# Offshore Wind Capital Costs and ITC for ORTP Calculation: A Proposed Amendment

Abby Krich and Alex Worsley, Boreas Renewables LLC

NEPOOL Markets Committee

October 6-8, 2020

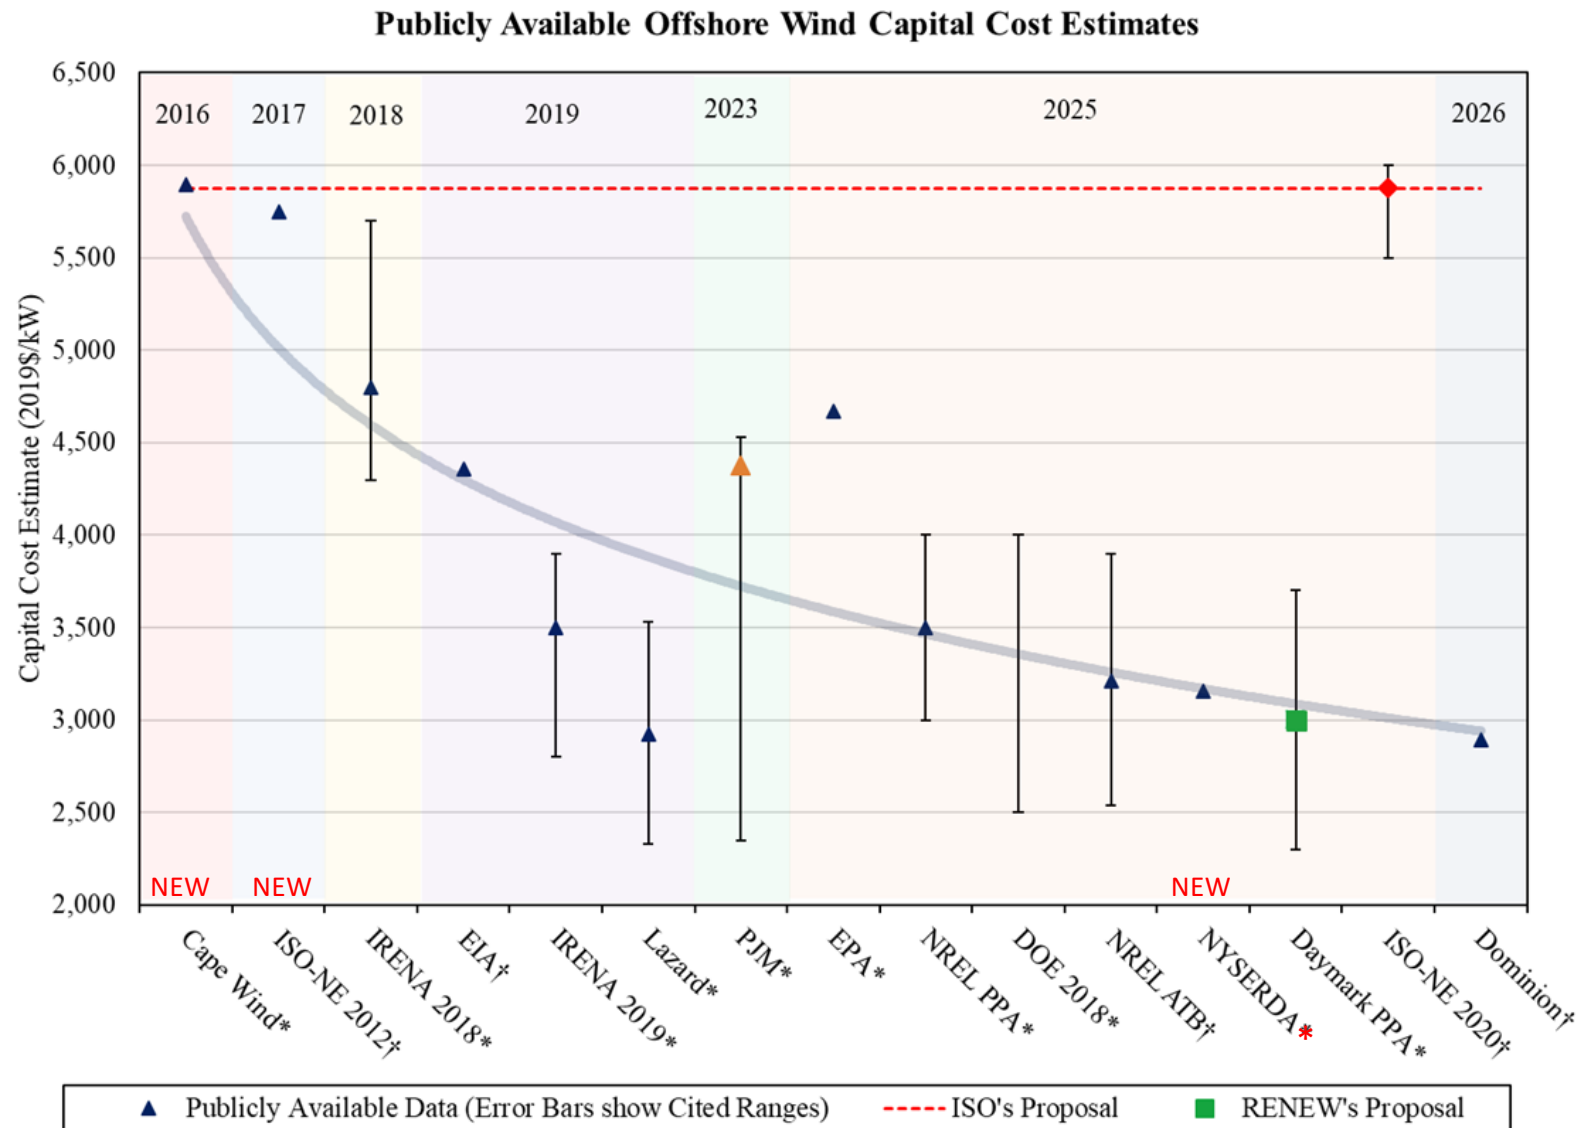
- RENEW has looked at a wide range of sources to gauge industry expectations for capital costs both globally and in the United States over time (Cape Wind, NREL, Lazard, DOE, IRENA, EPA, EIA, Dominion, NYSERDA, and PJM)
- This provides extensive benchmarking for the reasonable range of where the final value should land

# Interconnection Cost Benchmarking Data

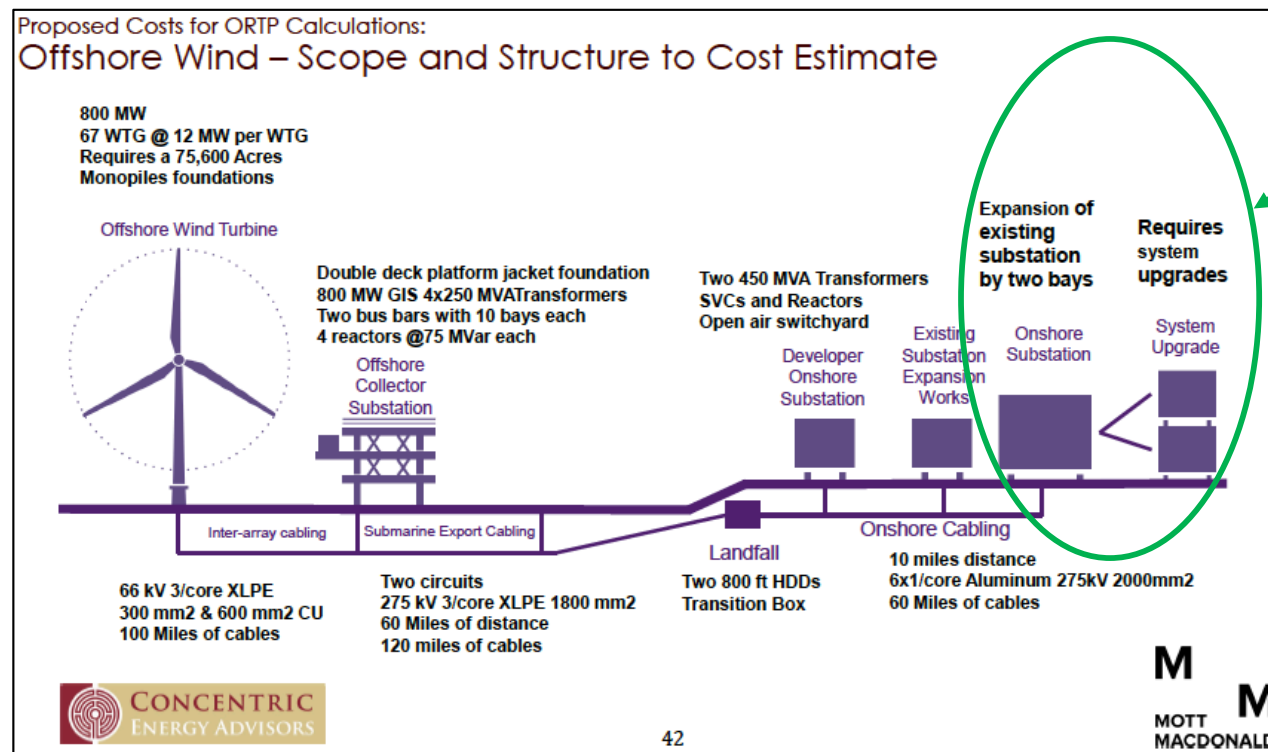
- The 14 OSW interconnection study results as of 9/29/2020 are summarized here
  - Study type is noted as Feasibility Study (FS) or System Impact Study (SIS)
  - Both FS and SIS reports provide non-binding good-faith cost estimates
  - SIS results are bolded
- QP618 is essentially identical to ORTP project
  - FS cost estimate was \$24.1M, SIS estimate was \$15.1M
  - FS and SIS both report cost estimate accuracy as -50%/+200%

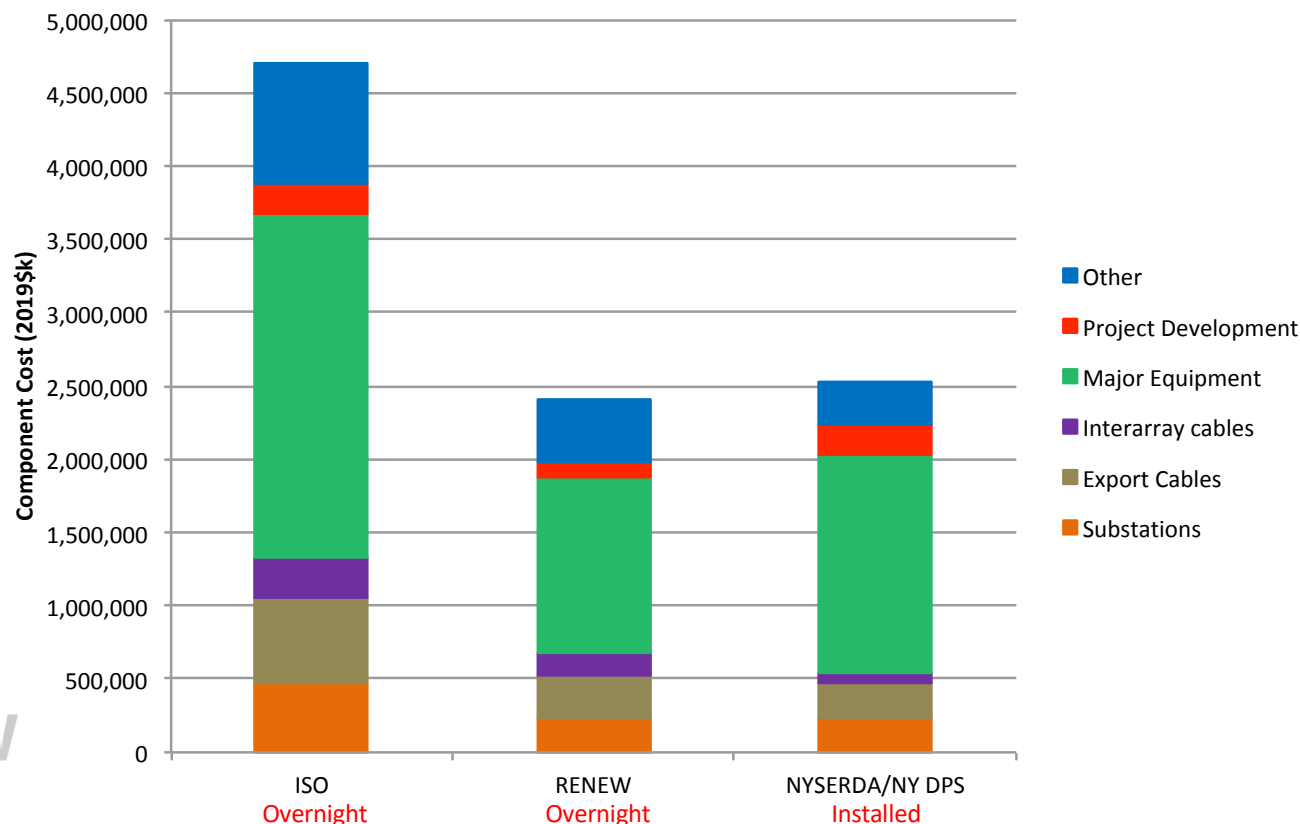
- RENEW broke down its total cost assumption of \$3,000/kW into the component line items in ISO's DCF model as shown below
  - ISO's ratios between categories were maintained with interconnection fixed at \$35.5M
- ISO and RENEW overnight cost components benchmarked against NYSERDA/DPS installed cost, shows good level of agreement between RENEW and NYSERDA/DPS
  - Components grouped here by color are detailed on the next slide
